Docket No. 50-312
Rancho Seco Nuclear Generating Station
License No. DPR-54
**SECOND 10-YEAR INTERVAL INSERVICE INSPECTION PROGRAM PLAN, REQUEST FOR
ADDITIONAL INFORMATION**

SACRAMENTO MUNICIPAL UTILITY DISTRICT
RANCHO SECO NUCLEAR GENERATING STATION
DOCKET NUMBER 50-312

Additional Information/Clarification Required

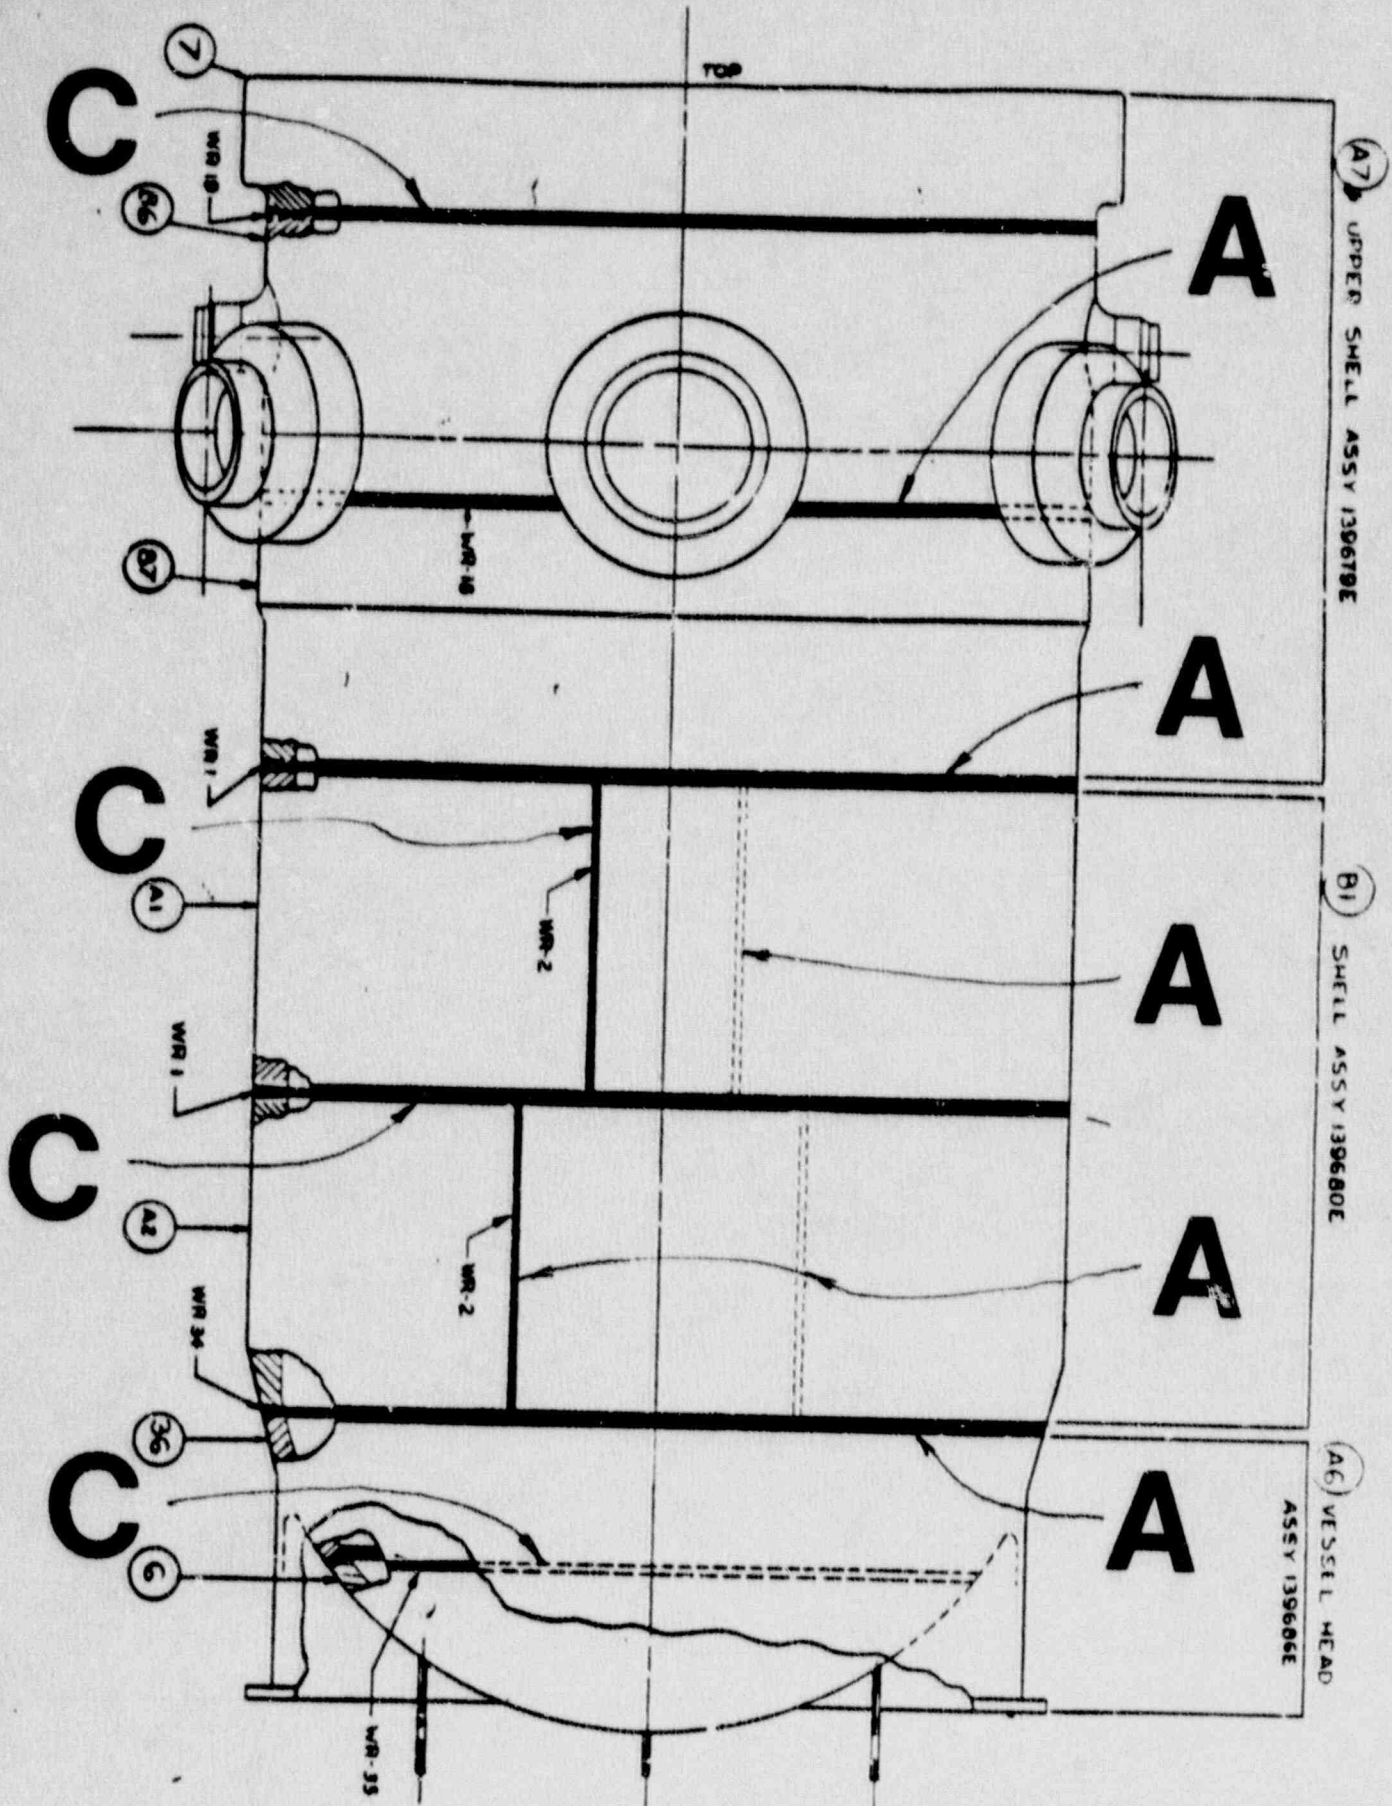
- (2) Regulatory Guide 1.150, Ultrasonic Testing of Reactor Vessel Welds During Preservice and Inservice Examinations;

Response - Attachment 1 shows the quantity of circumferential and longitudinal welds in the Reactor Vessel. They are labeled to show those to be examined due to ASME Code requirements (noted C), and those also to be examined as stated in the Program Plan as augmented (noted A). The Code requires three of the six circumferential and one of the four longitudinal welds to be examined. Our augmented program picks up the remaining three circumferential and three longitudinal welds. Thus, all reactor vessel welds will be 100% volumetrically examined from the inside surface, as well as all eight nozzle welds.

C = CODE REQMTS

A = AUGMENTED
